Service Bulletin 57

Subject: Aileron Crossover Cable Lengths

Applicability: All Sportsman Kits

<u>Issue</u>: New Cable Lengths

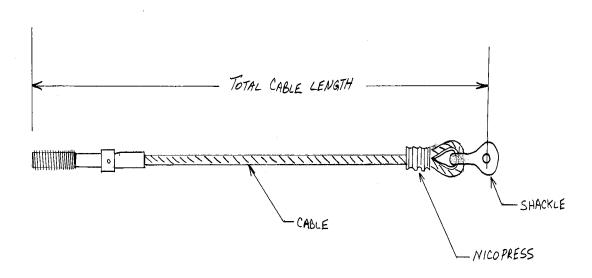
If you have pre-fabricated the LH Aileron Crossover Cable to the previous dimensions, the shorter cable may be lengthened by substituting a flap cable attach tab 602-02020-01FP (ref. Section IX, p. 145, fig. 84) in place of the supplied aileron cable attach tab 602-06002-01 (ref. Section IX, p. 136, Fig. 79). (Note that the flap attach tab has end-hole dimensions ¾" longer than the aileron attach tab and a center hole which is ignored.) If you need the ¾" extension, contact the Customer Service / Parts department at 360-435-8533 X221 or parts@glasairaviation.com and explain that you are calling in reference to Service Bulletin 57 and are in need of part # 602-02020-01FP.
